Technical Bulletin

Subject: CYLINDER HEAD GASKET FOR THE TU-FLO 550/750 AIR COMPRESSORS

Cylinder Head Gasket

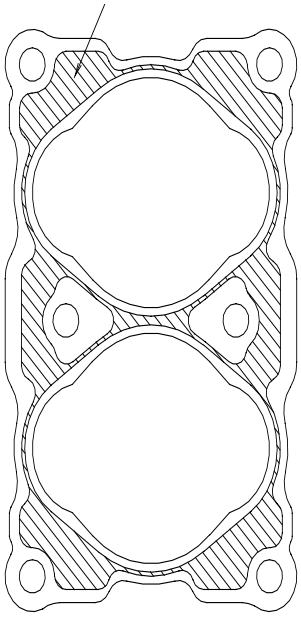
A design change to the cylinder head gasket for the Tu-Flo 550/750 compressors has resulted in a gasket orientation change. When installing the cylinder head gasket the beaded side of the gasket must face the compressor crankcase when assembled.

Bead on one side
